Loreto Kirribilli Response to Submission

Concept Master plan and Stage 1

Project Name		Loreto Kirribilli - Concept Master plan and Stage 1	
Project Code		LKMP	
Document Name		Architectural Design Statement	
Document ID		LKMP Response to Submission	
Revision	Date	Comment	Approved
00	29/01/18	RTS Submission	EC

W7 - OBLIQUE VIEW

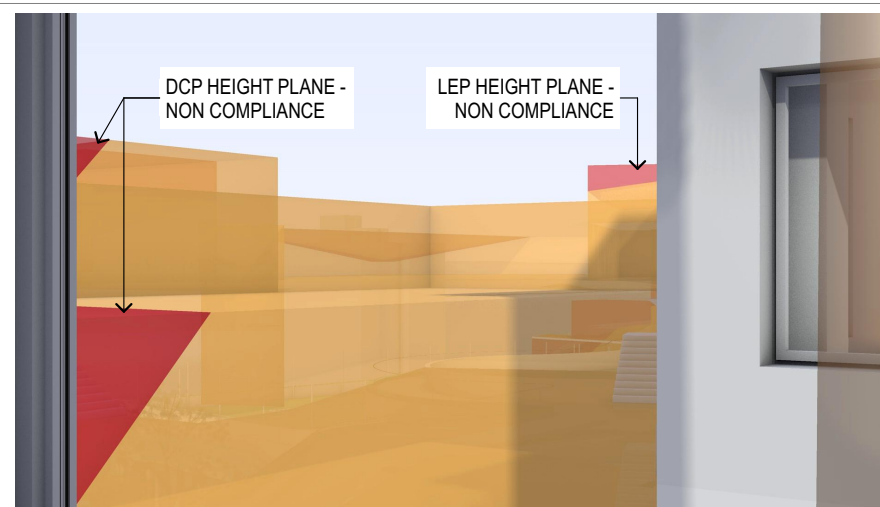
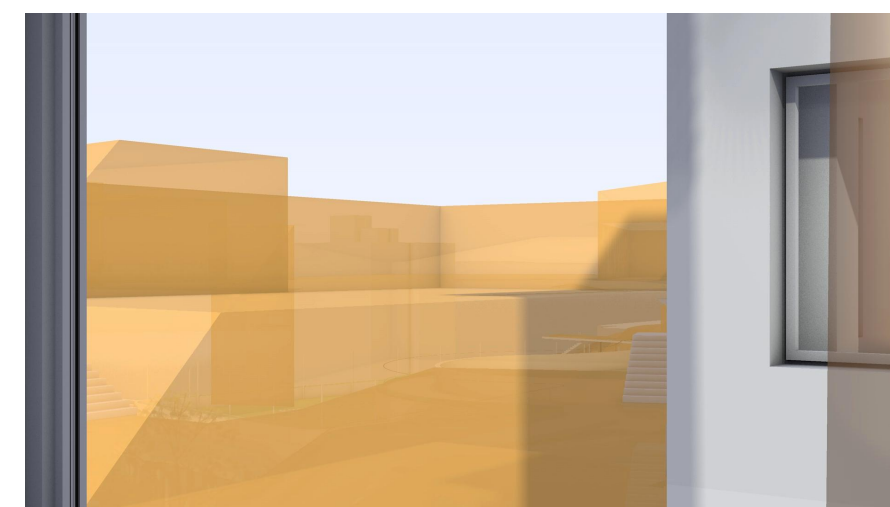
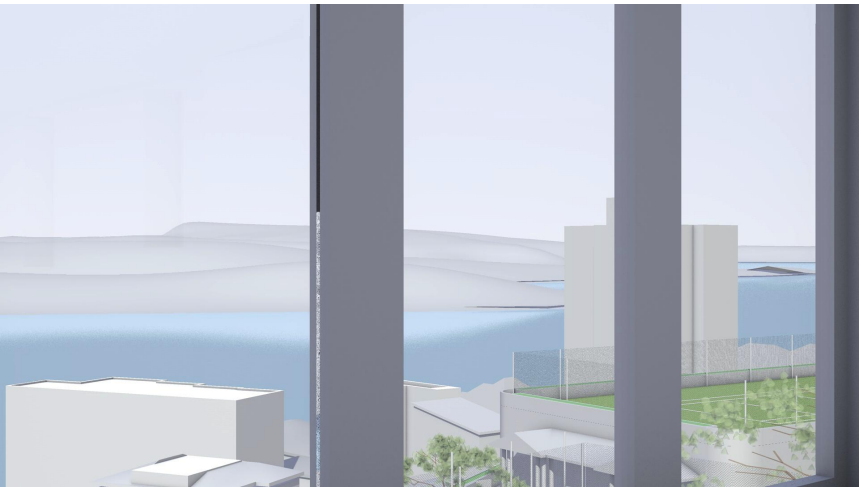
4.0	North Sydney Council	
4.1	Planning - North Sydney Local Environmental Plan 2013	
5.0	Views	
5.1	Concern is raised that there will be loss of views to high amenity water views currently afforded from the eastern outlook from 111 Carabella Street, Kirribilli. A reduction to the height and depth to the building can ameliorate the potential impact.	Refer response to item 2 and SKMP- 60.4

It is acknowledged that the proposed development envelope will obstruct the existing harbour views, however this portion of the obstructed view is within the complying envelope (as indicated in orange). In order to maintain the harbour views illustrated in the provided photograph the height of the development would be required to match that of the existing B-Block at RL33.620 which is approximately 3m below the allowable 12m LEP height plane.

The non compliant elements as indicated in red include the lift overrun. This protrusion of this element above the LEP height plane is considered a minor impact.

3.0 Figure 2 Summary of Amendments Post Community Consultation

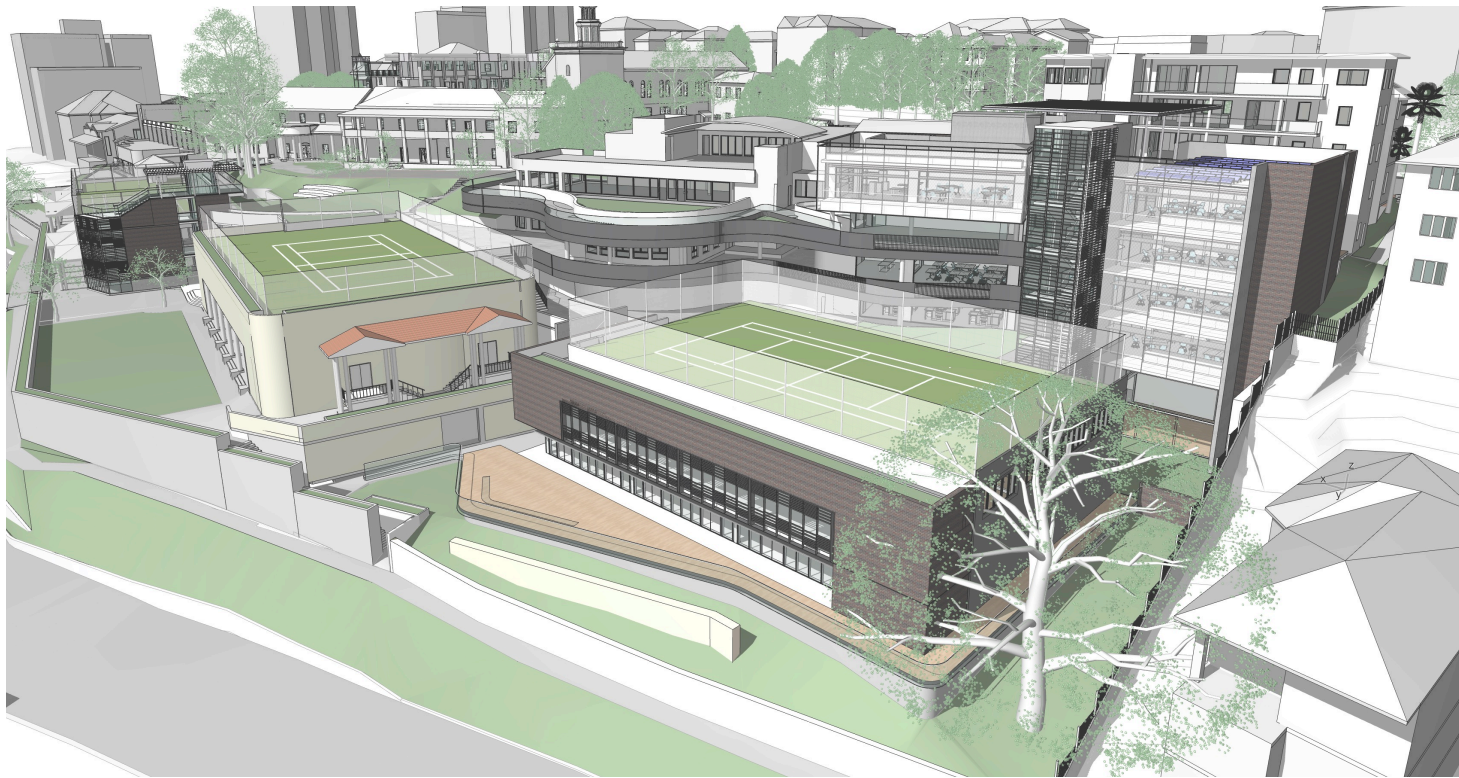
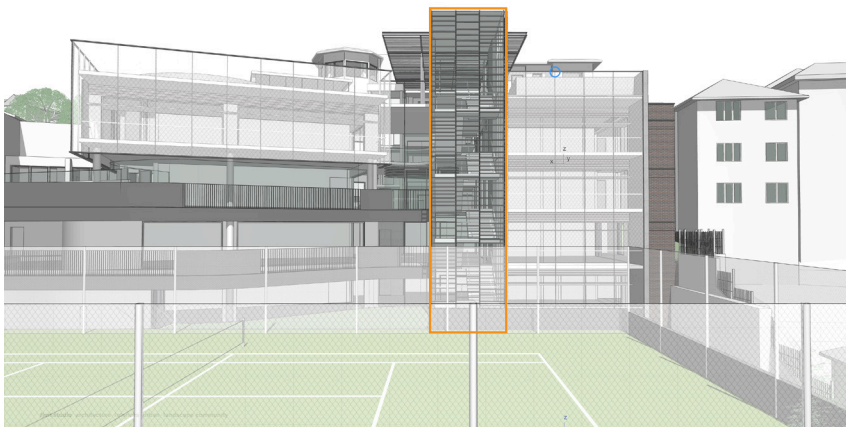
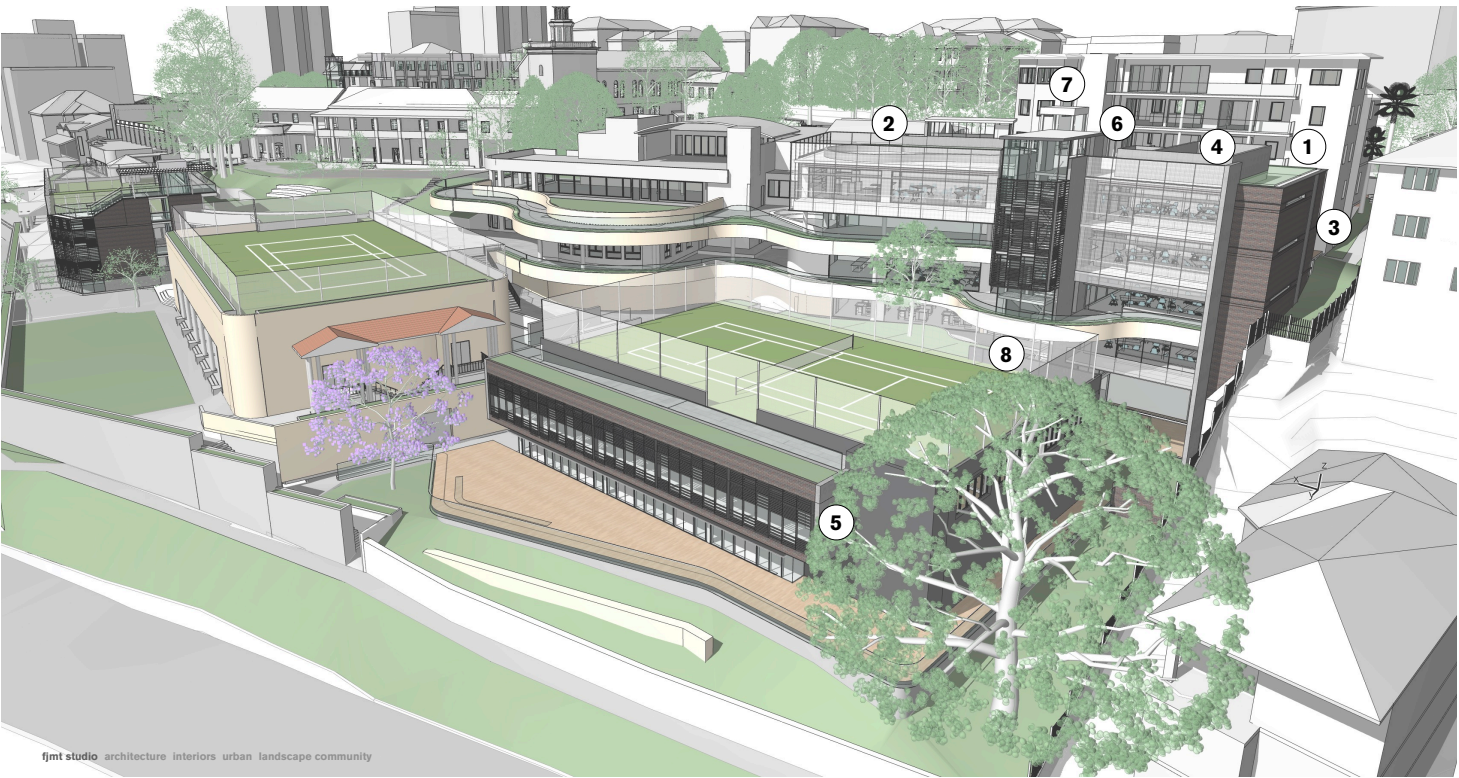
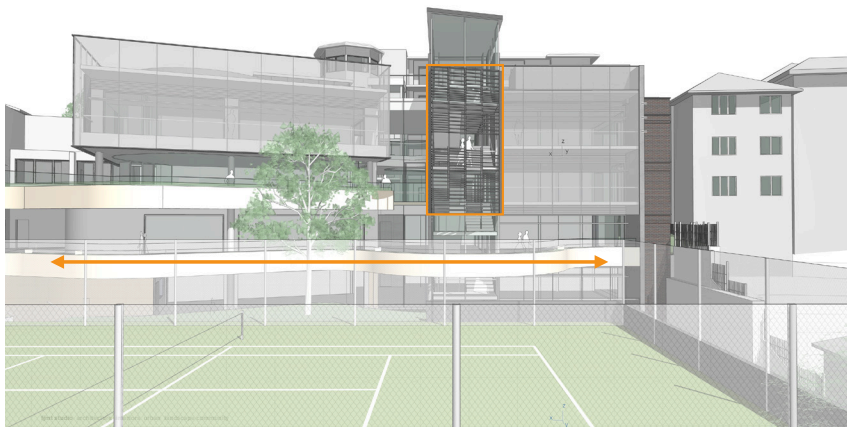
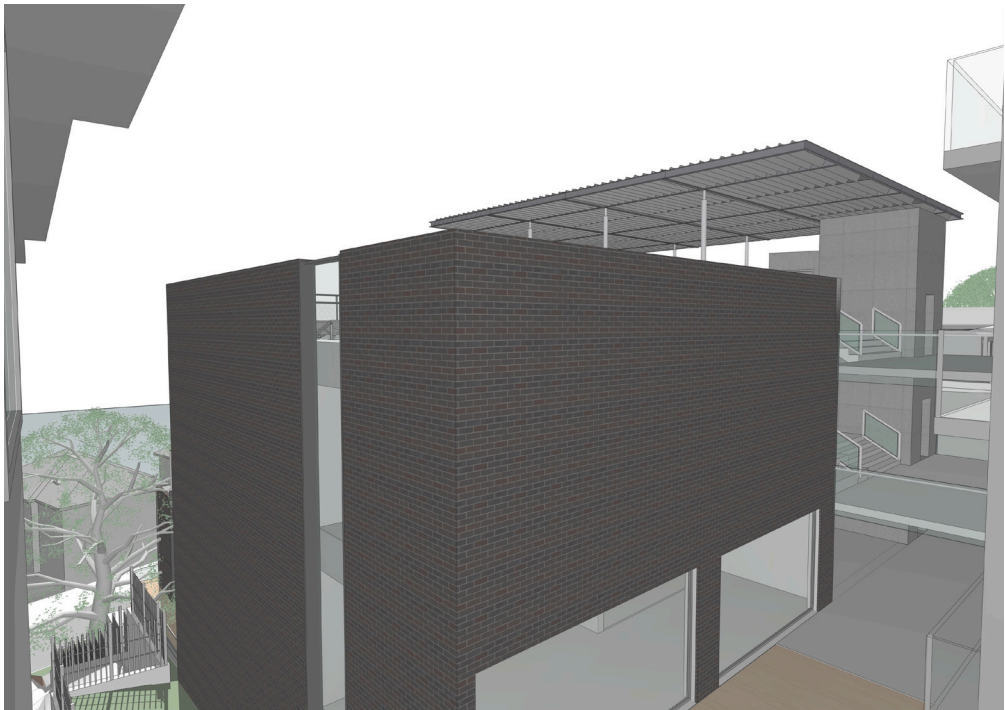
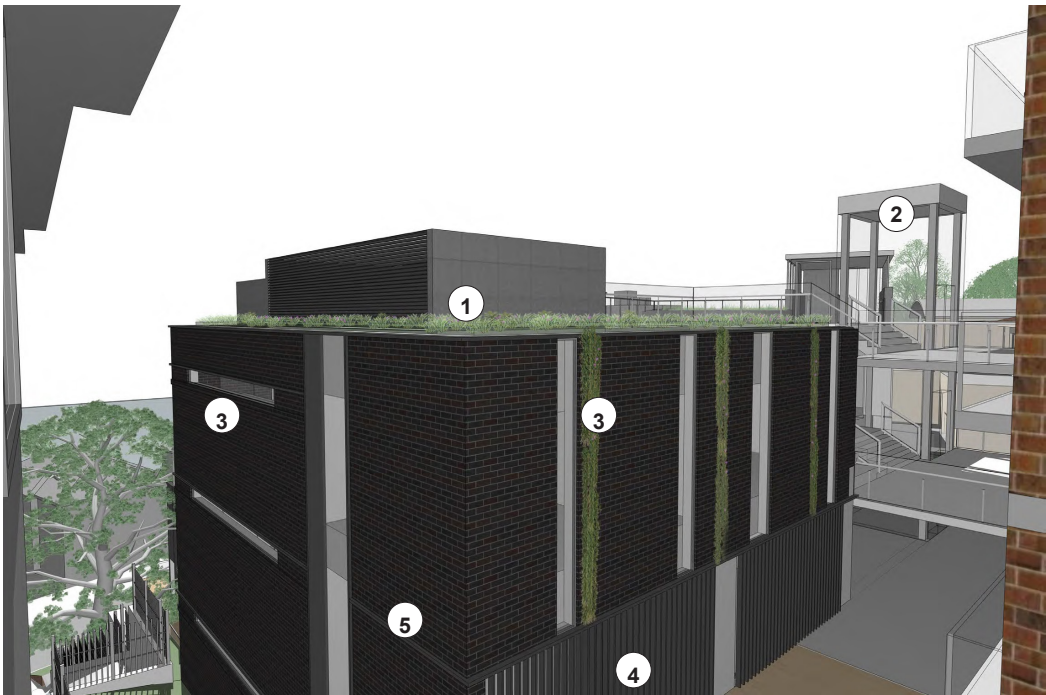
3.13	The amenity of the existing buildings and grounds will be protected and in some cases improved by the proposal. The amenity of a small amount of adjacent apartments is adversely affected.	Noted. As detailed throughout this response, measures have been implemented to minimise amenity impacts on adjacent apartments. Refer Figure 2

- 1 Parapet reduced in height and introduction of an integrated planter creating a landscaped buffer to 111 Carabella Street.
- 2 Increased roof garden
- 3 Western boundary facade articulation; through high level windows and brick detailing
- 4 Relocated and reduced footprint of mechanical plant - Acoustically treated
- 5 Building setback to improve access to light and air - 22 Elamang
- 6 Louvred roof removed
- 7 Glazed Lift
- 8 Reduced bulk and scale of connector form

- ① Parapet reduced in height
Integrated planter
creating a landscape
buffer to 111 Carabella St
- ② Glazed lift
- ③ Introduced high level windows
and slot windows
- ④ Privacy screen
- ⑤ Brick detailing

4.1 111 Carabella Street North Eastern Elevation

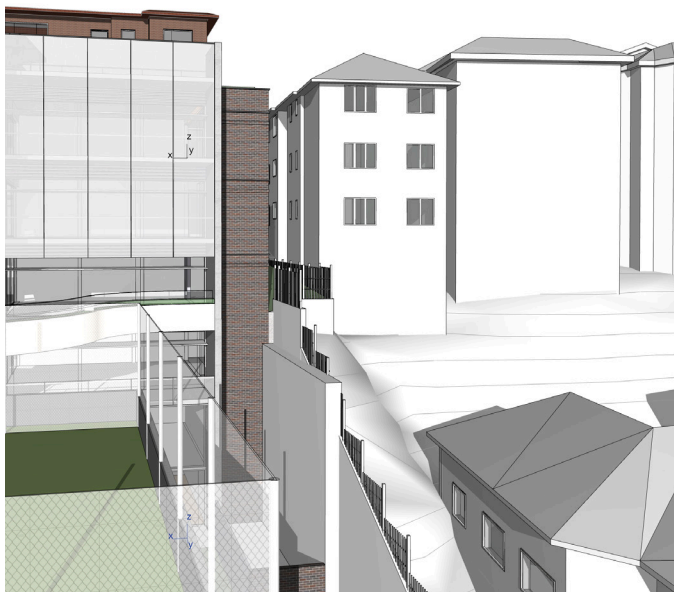
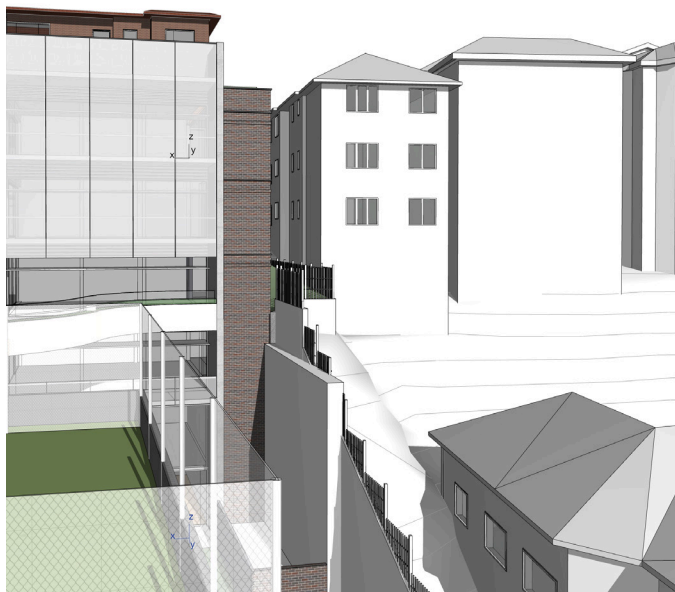
The proximity to the boundary of the new Learning Hub building inclusive of the overall height of the building. The depth of the building is such that shadowing to 111 Carabella Street will be expanded and extended to being to cover the north eastern elevation of the building and further reduce

The bellow views illustrate solar access to the North Eastern Elevation of 111 Carabella during the morning on June 21. It can be seen that the proposed building will not impact the available solar access to this elevation.

4.3 Figure 4 Solar Access PDHPE Lower Ground Level 3 and 4

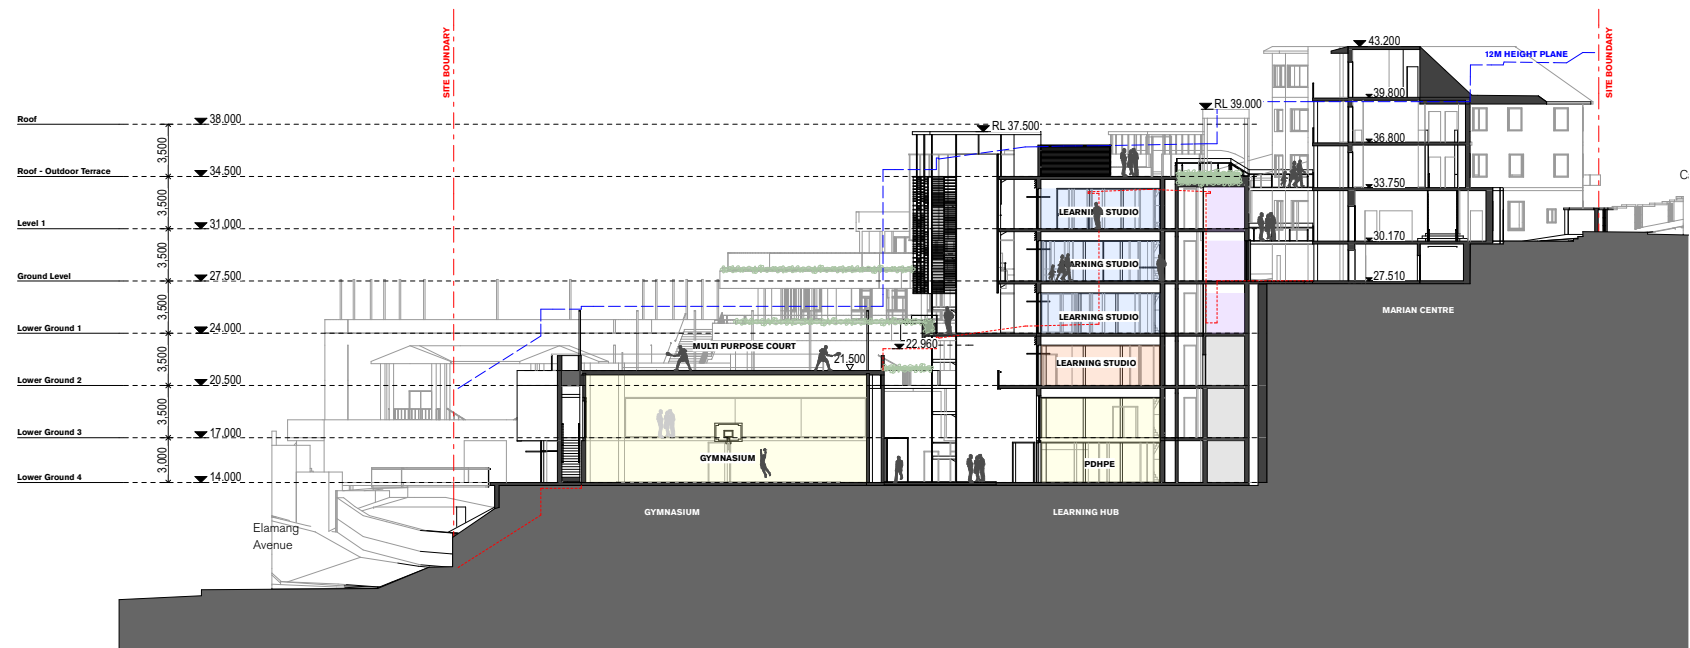
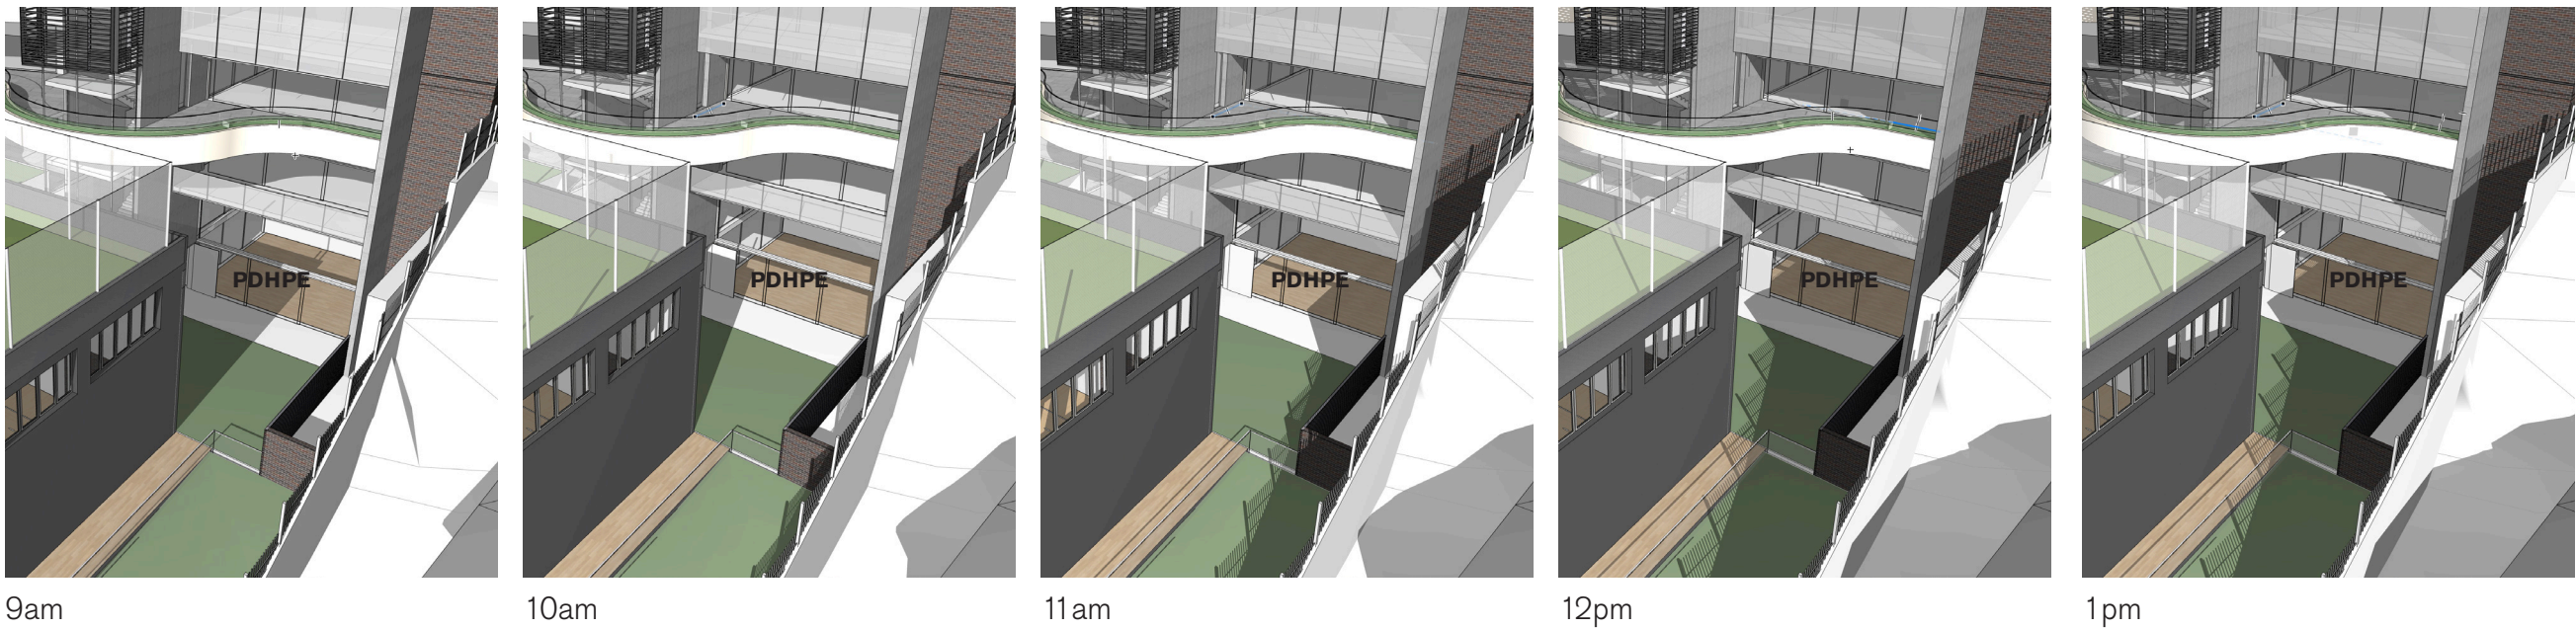
Comment : Satisfactorily provide natural light and air to all learning spaces including the PDHPE classrooms in Lower Ground 3 and 4 of the Learning Hub.
